Service Bulletin No. 155
FAA DOA EA-4 Approved

Subject: Bondline Protection

Serials Affected:	AA1, AA1A's	0001 & Sub.
	AA1B	0001 thru 0641
	AA5's	0001 & Sub.
	AA-5A	0001 thru 0173
		0176 thru 0196
	AA-5B	0001 thru 0309
		0311 thru 0324

FIGURE 1

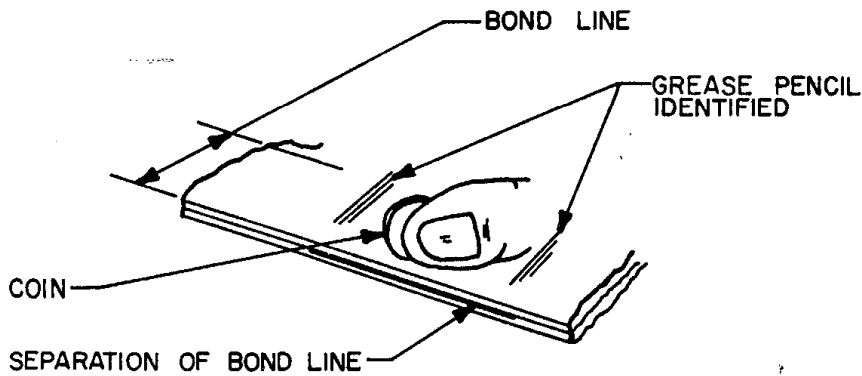
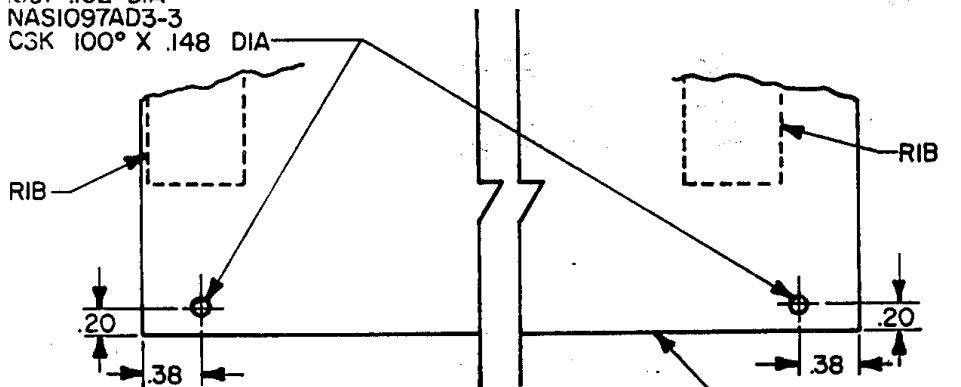
- A. Carefully scan the edges of all joints in a well lighted hangar or outside in daylight to determine the existence of hairline cracks between two layers of bonded metal. Figure 1 shows the appearance of this condition. Identify the location of any cracks with a grease pencil as shown in Figure 1.

- E. Flap Rework - AA1 0001 and Sub. , AA1A 0001 and Sub. and AA1B 0001 - 0579.
 - 1. Drill .097 - .102 Dia. Hole in outboard and inboard ends of flaps. (See Figure 1). Countersink holes 100° x .148 Dia. Both sides of hole. Care should be used when countersinking, so as not to take out too much material.
 - 2. Install NAS1097AD3-3 Rivet, wet with zinc chromate primer (MIL-P-8585). Rivet shall be flush both sides.

- F. Flap Rework - AA5 0001 and Sub. , AA5A 0001 - 0179 and AA5B 0001 - 0293.
1. Drill .097 - .102 Dia. Hole in outboard and inboard ends of flaps. (See Figure 1). Countersink holes 100° x .148 Dia. both sides of hole; Care should be used when countersinking, so as not to take out too much material.

C97-.102 DIA
 NAS1097AD3-3
 CSK 100° X .148 DIA

NOTES: COUNTERSINK UPPER & LOWER SURFACE SKIN.

INSTALL ALL RIVETS WET USING ZINC CHROMATE PRIMER MIL-P-8585.

MS20470AD3- RIVET MAY BE SUBSTITUTED FOR NAS1097AD3-3.

FIGURE 2

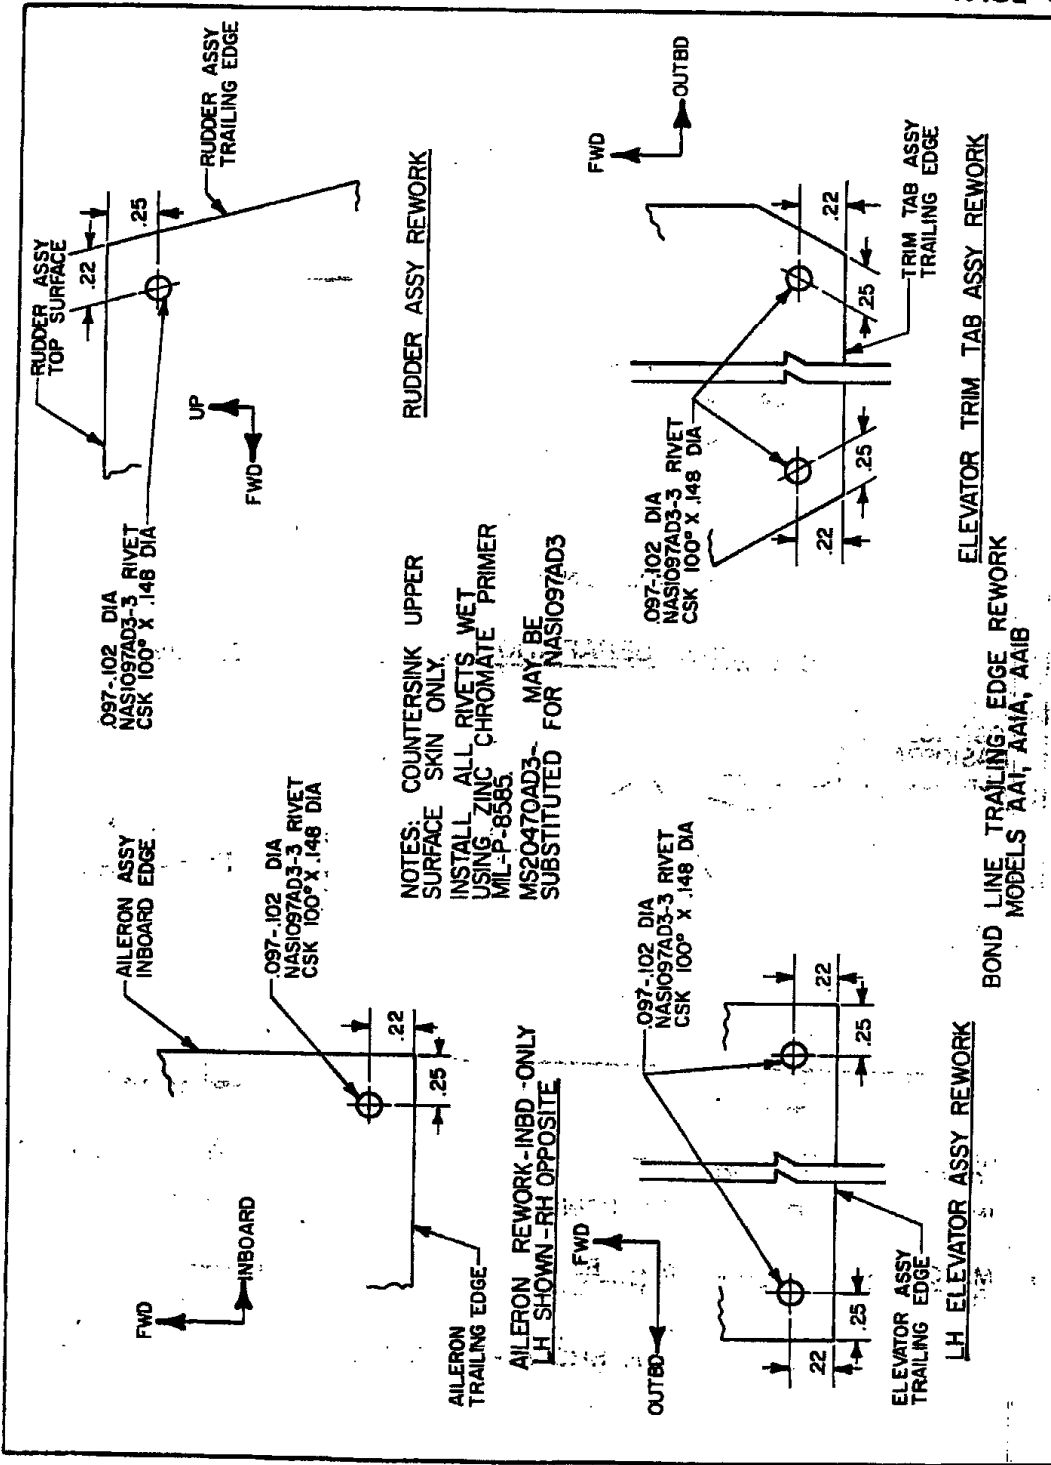
1. On inboard end of ailerons drill .097 - .102 Dia. Holes (See Figure 2). Countersink hole 100° x .148 Dia. on upper surface skin only. Install NAS1097AD3-3 Rivet, wet with zinc chromate primer (MIL-P-8585).

2. On inboard and outboard end of elevator trim tab, drill .097 - .102 Dia. Hole (See Figure 2). Countersink holes 100° x .148 Dia. on upper surface skin only. Install NAS1097AD3-3 Rivet, wet with zinc chromate primer (MIL-P-8585).

3. On top of rudder drill .097 - .102 Dia. Hole (See Figure 2). Countersink hole 100° x .148 on L/H side only. Install NAS1097AD3-3 Rivet wet with zinc chromate primer (MIL-P-8585).

4. On inboard and outboard end of L/H elevator drill .097 - .102 Dia. Holes (See Figure 2). Countersink holes 100° x .148 Dia. on upper surface skin only. Install NAS1097AD3-3 Rivet, wet with zinc chromate primer (MIL-P-8585).

FIGURE 3

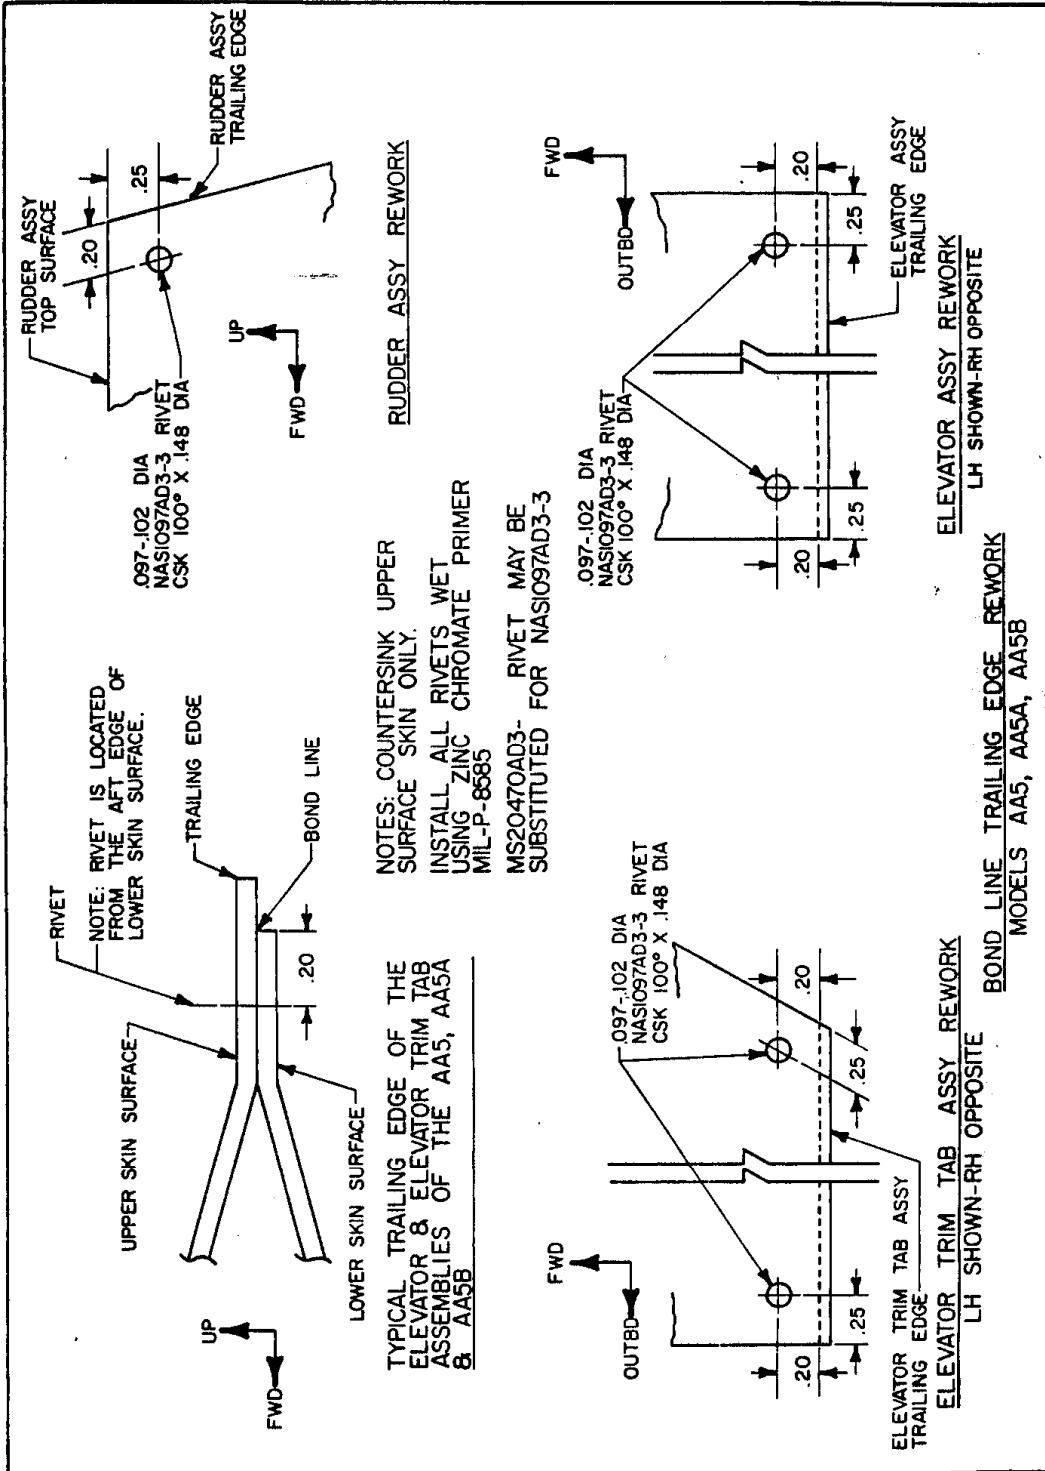
- H. Bondline trailing edge rework - AA5, AA5A and AA5B.
1. On top of rudder hole drill .097 - .102 Dia. Hole (See Figure 3). Countersink hole 100° x .148 on L/H side only.

2. Install NAS1097AD3-3 Rivet, wet with zinc chromate primer (MIL-P-8585).
 3. On inboard and outboard ends of elevator trim tab drill .097 - .102 Dia. Hole (See Figure 3). Countersink holes 100° x .148 Dia. on upper surface skin only. Install NAS1097AD3-3 Rivet, wet with zinc chromate primer (MIL-P-8585).

4. On AA-5A and AA-5B elevators drill .097 - .102 Dia. Hole in both elevators in inboard and outboard ends. Countersink holes 100° x .148 Dia. on upper surface skin only. (See Figure 3). Install NAS1097AD3-3 Rivet, wet with zinc chromate primer (MIL-P-8585).
